Subject: Upper Rad Door Panel Bulging			
Field Change Program: Procedure	Procedure number: 03-263	Revision: A	Date: 11/21/2019
Coach Section: 03- Body	P/N: 03-32-3275		Type: Product Integrity

1.0 Description

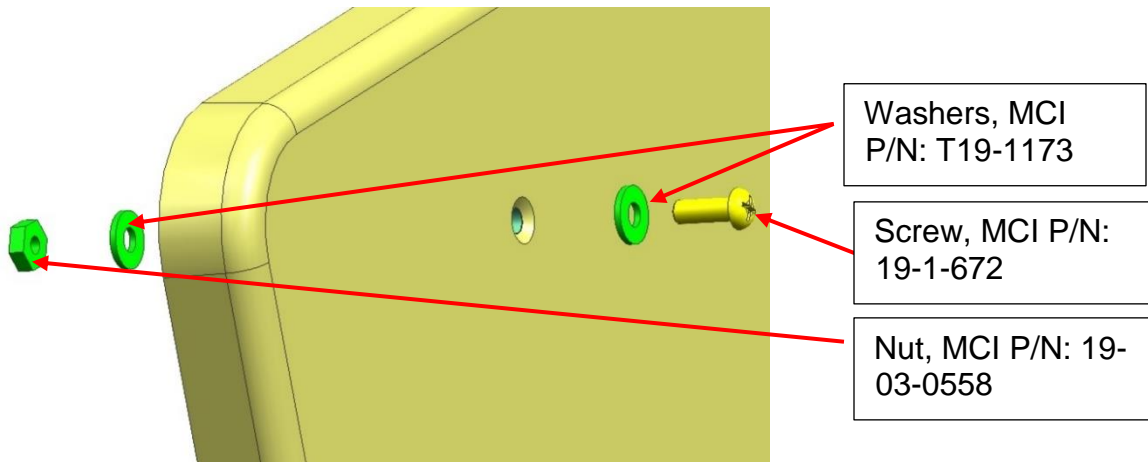
Remove the four rivets on the rad panel by drilling through them.

Secure the panel to the bracket using screws, MCI P/N: 19-1-672, washers, MCI P/N: T19-1173, and nuts, MCI P/N: 19-03-0558 as shown below. Torque the nuts to 20 In-Lbs.
